AP1000 DOCUMENT NO. APP-GW-GLR-134	REVISION 1	PAGE 1 of 470	ASSIGNED TO W-Sterdis	OPEN ITEMS (Y/N)
----------------------------------------------	----------------------	-------------------------	---------------------------------	------------------

TITLE: AP1000 DCD Impacts to Support COLA Standardization

AP1000 Standard Combined License Technical Report

AP1000 DCD Impacts to Support COLA Standardization

Figure 3.8.2-4 (Sheet 2 of 6)

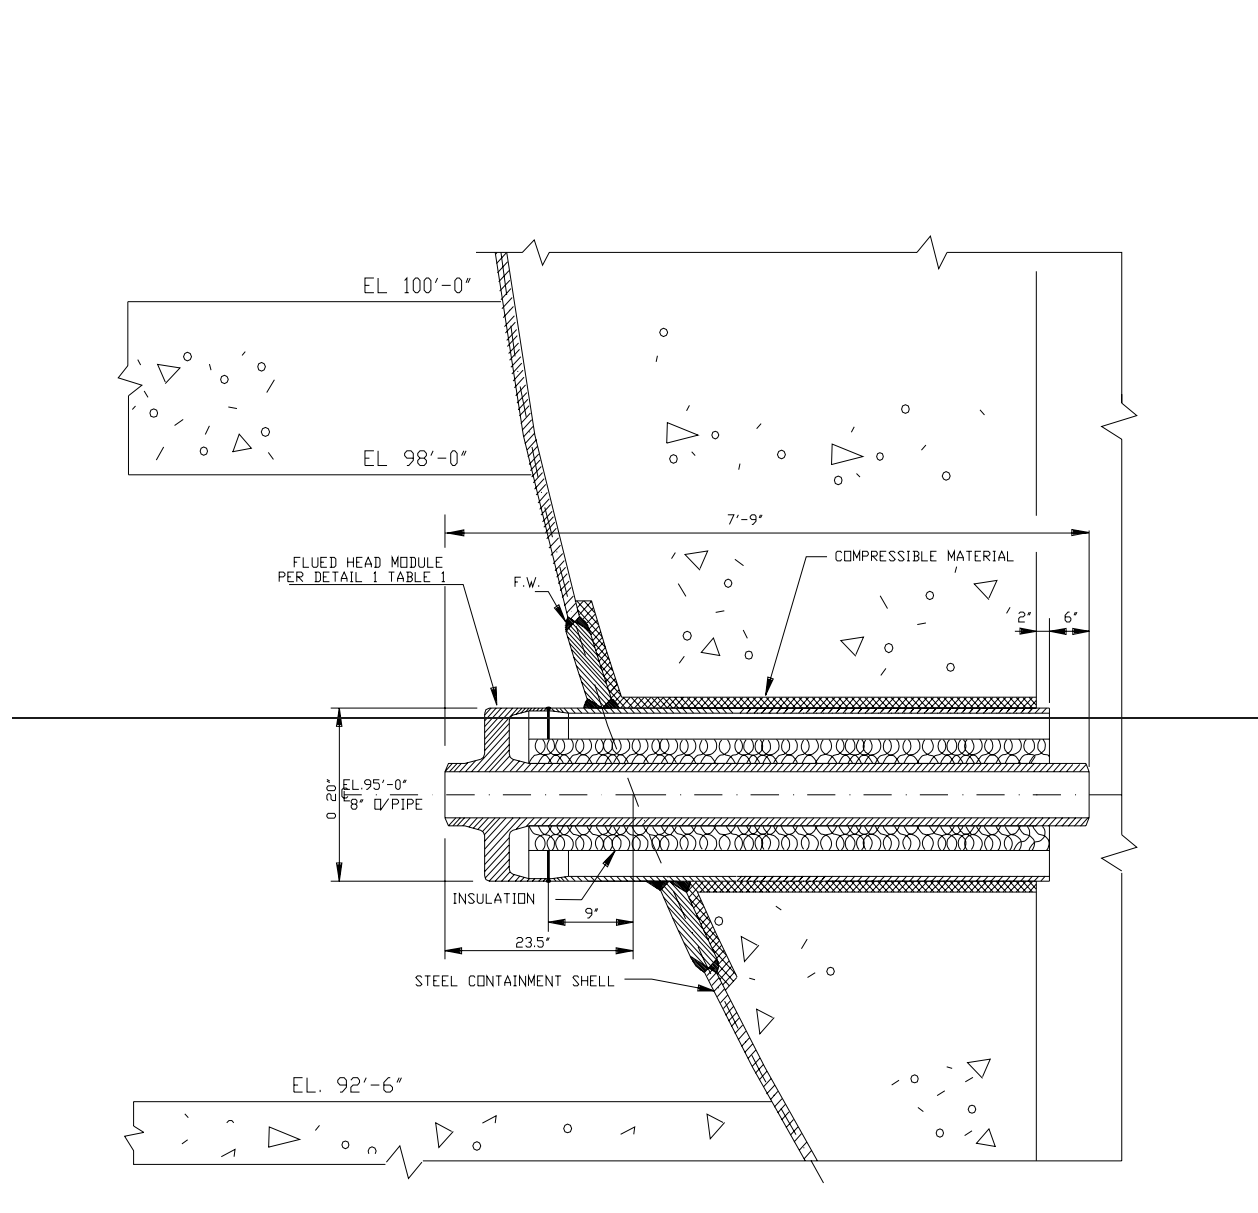
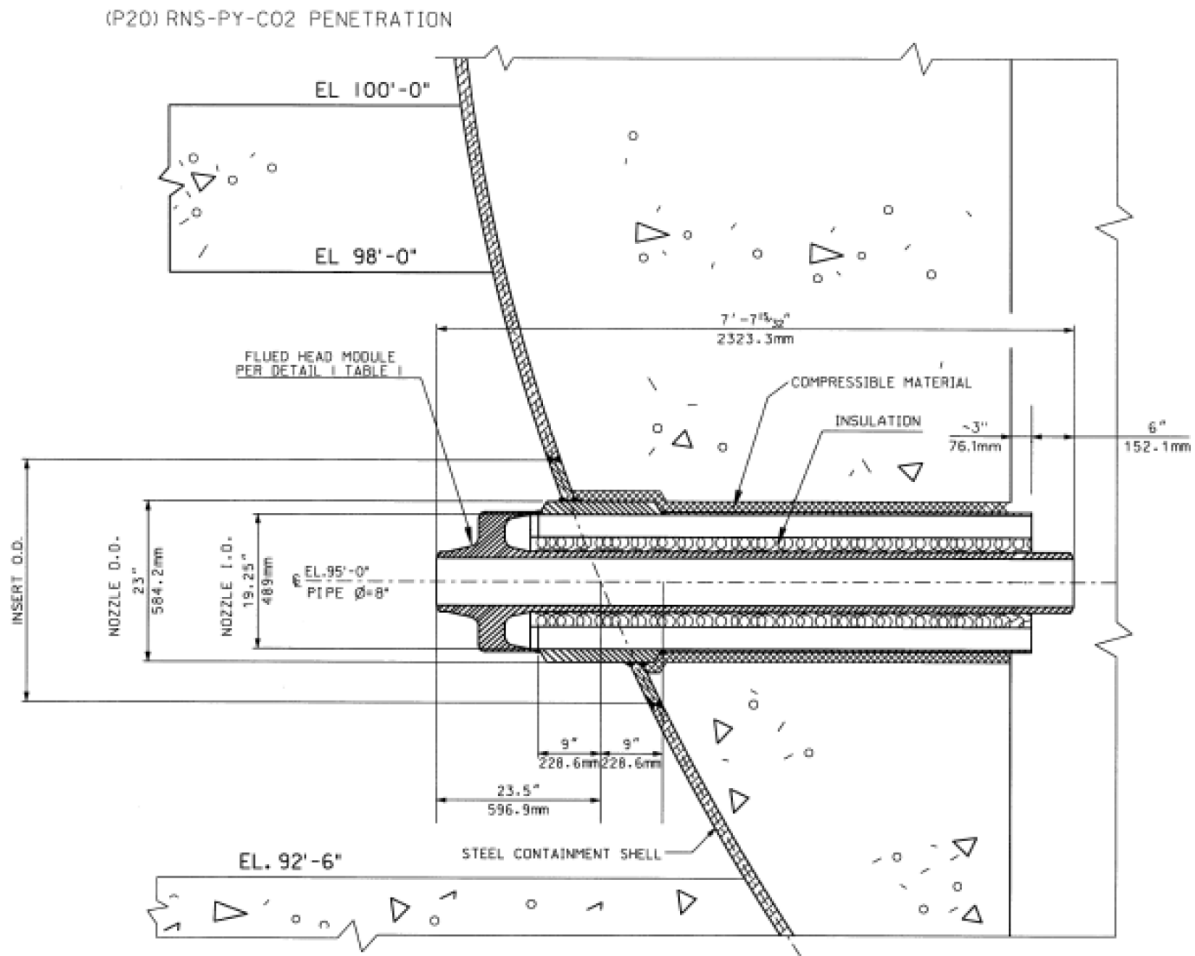
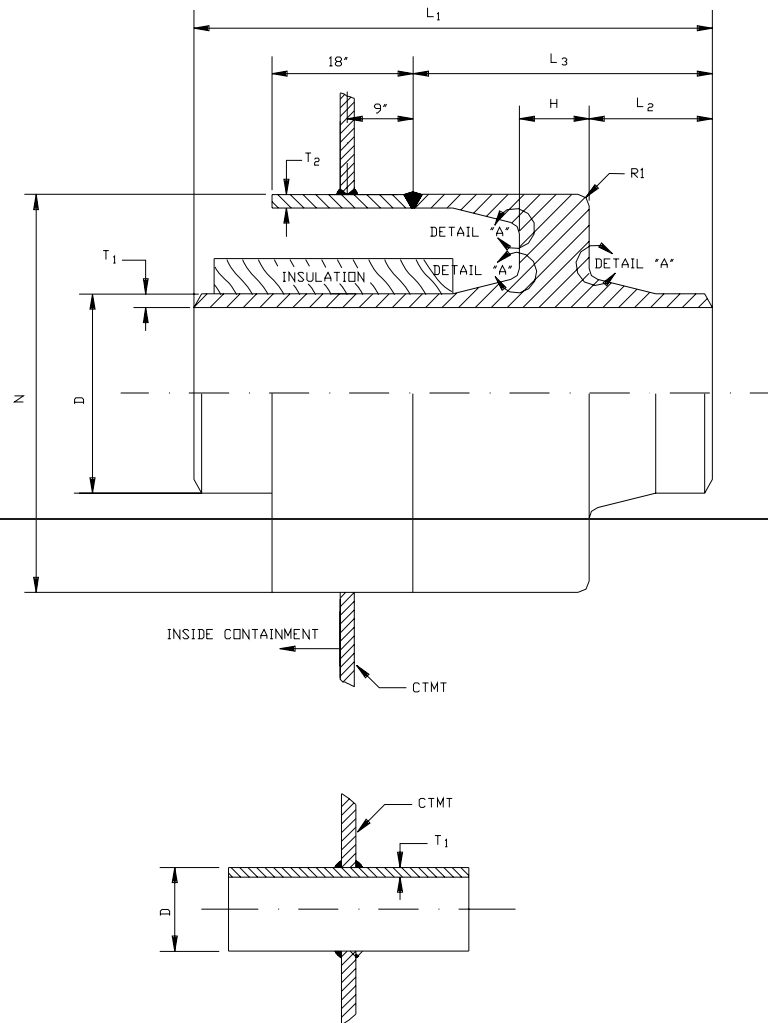
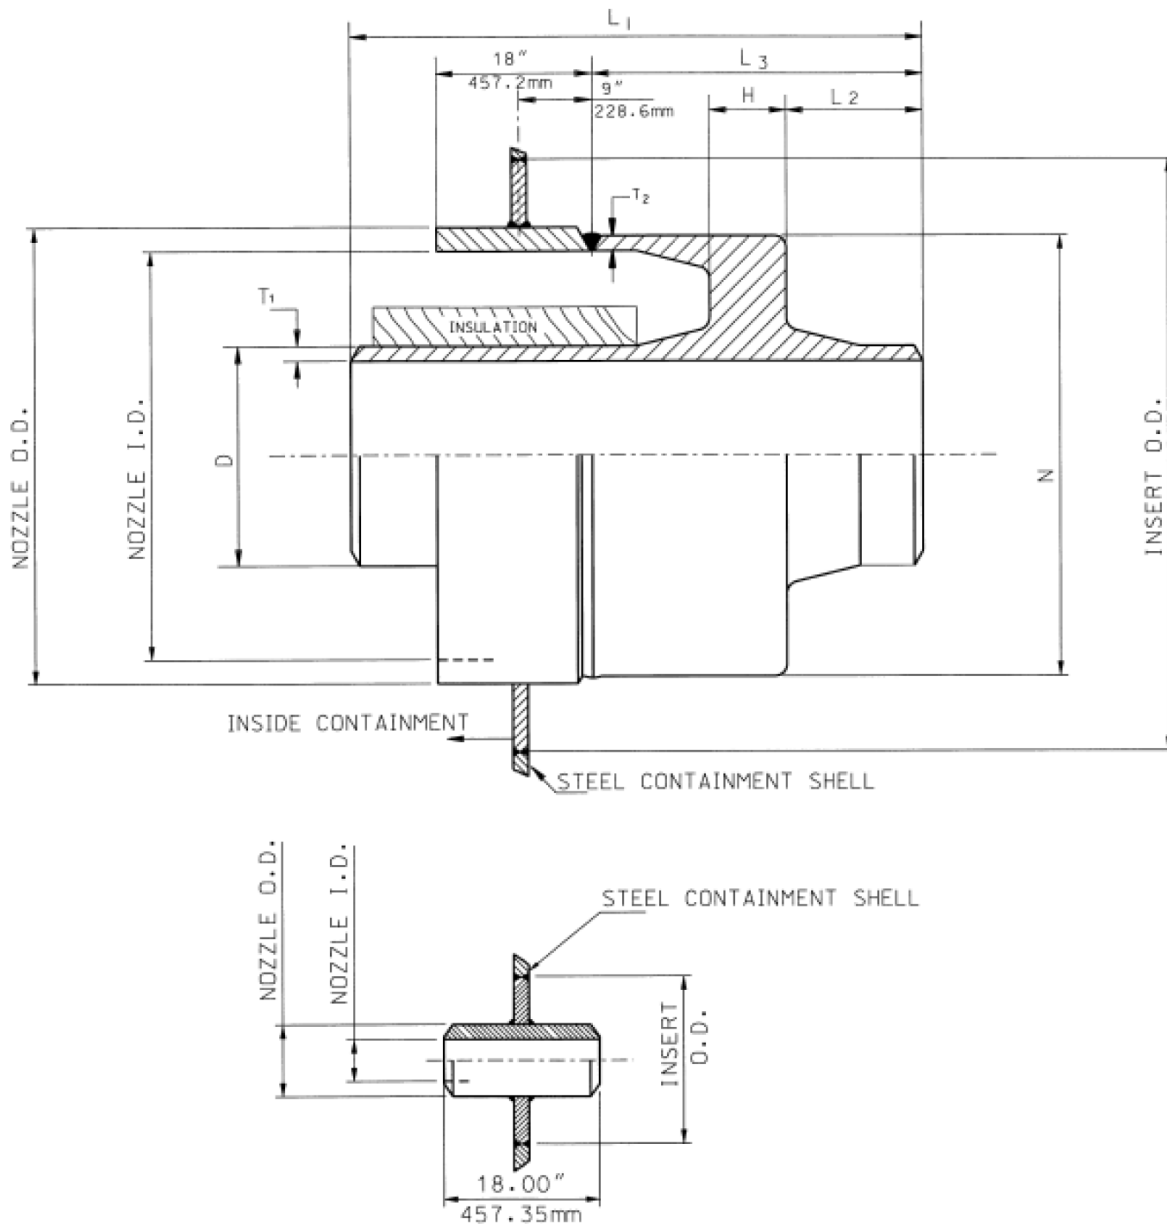
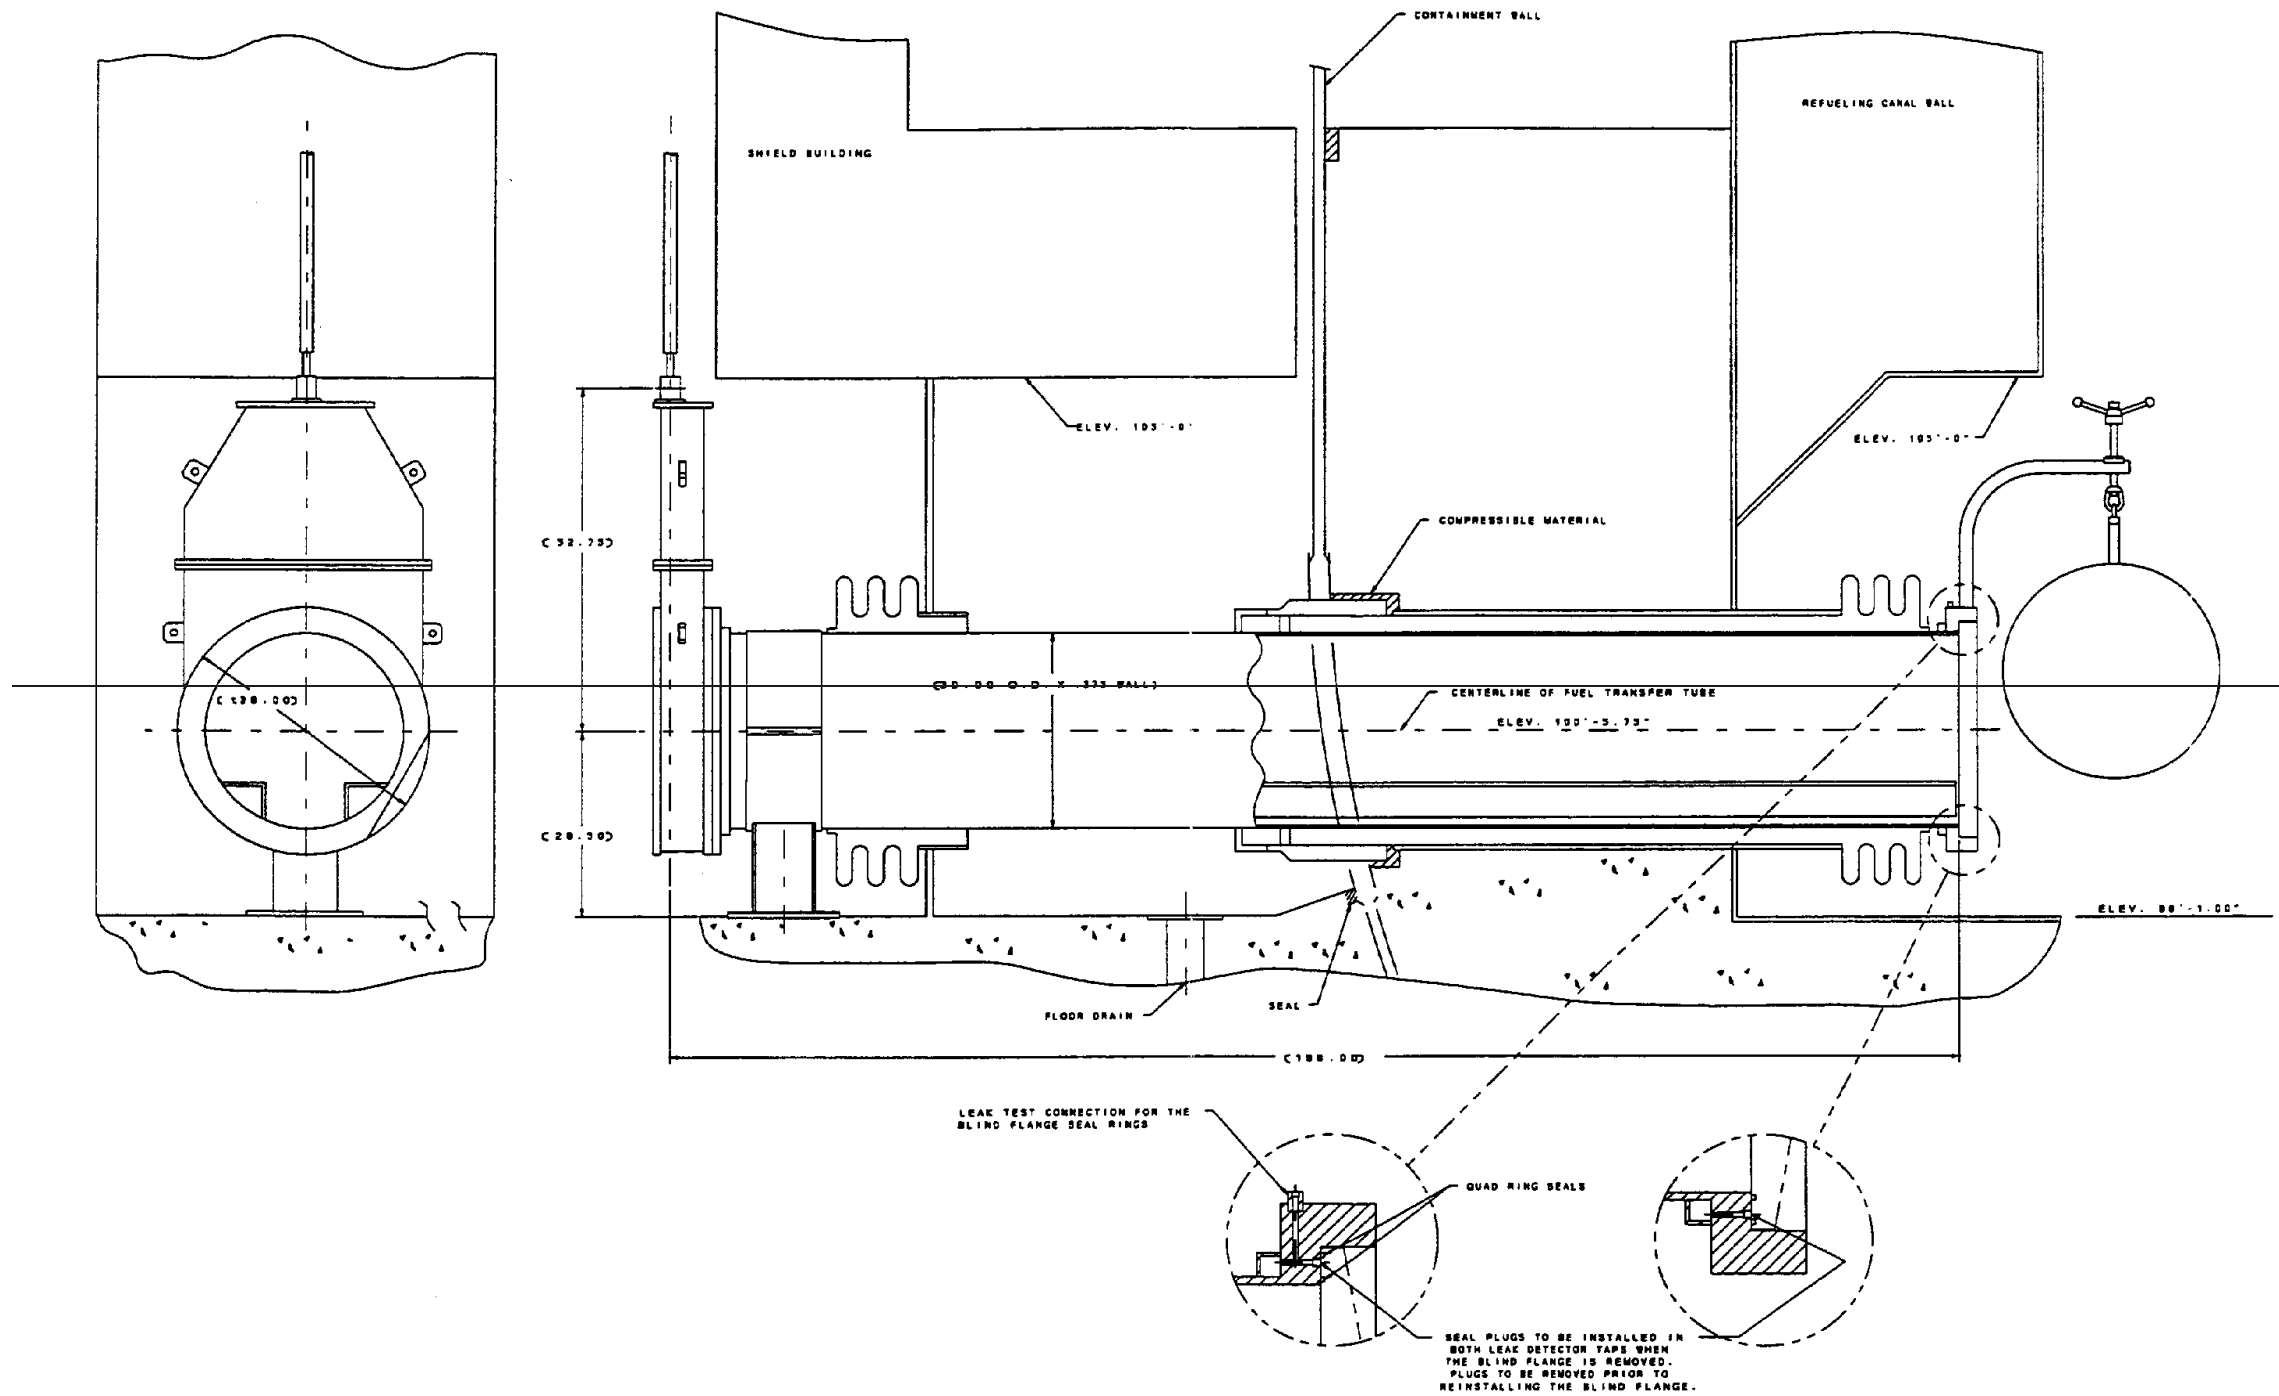
NRC044 contains corrections to Table 3.2-3, Figure 3.8.2-4 of DCD Revision 16. The basis for the change is RAI-TR09-003.
